Korenix JetNet Industrial Managed Switch JetNet 4510 SOFTWARE RELEASE Notes

About This Software Version

The following changes apply to the version v 2.1:

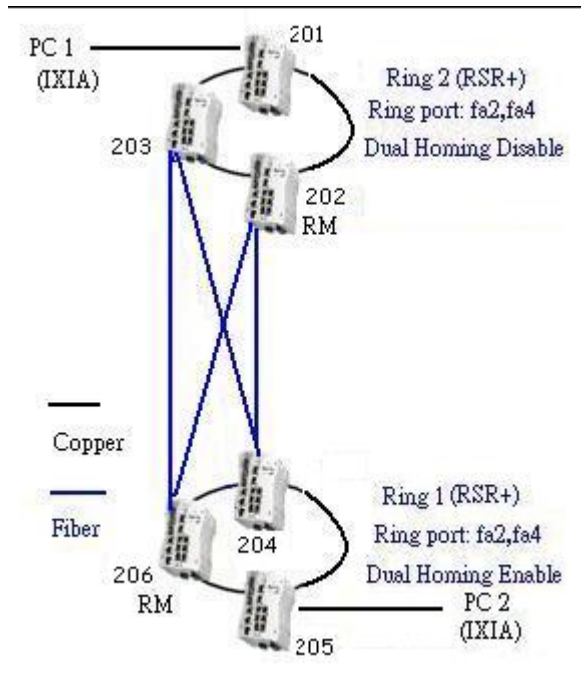
- Rename Rapid Super Ring to Multiple Super Ring with various features as following diagram.

- Implement new ring algorithm, the restore time of Rapid Super Ring (R.S.R.) and Rapid Dual Homing (R.D.H.) reduced to zero second.
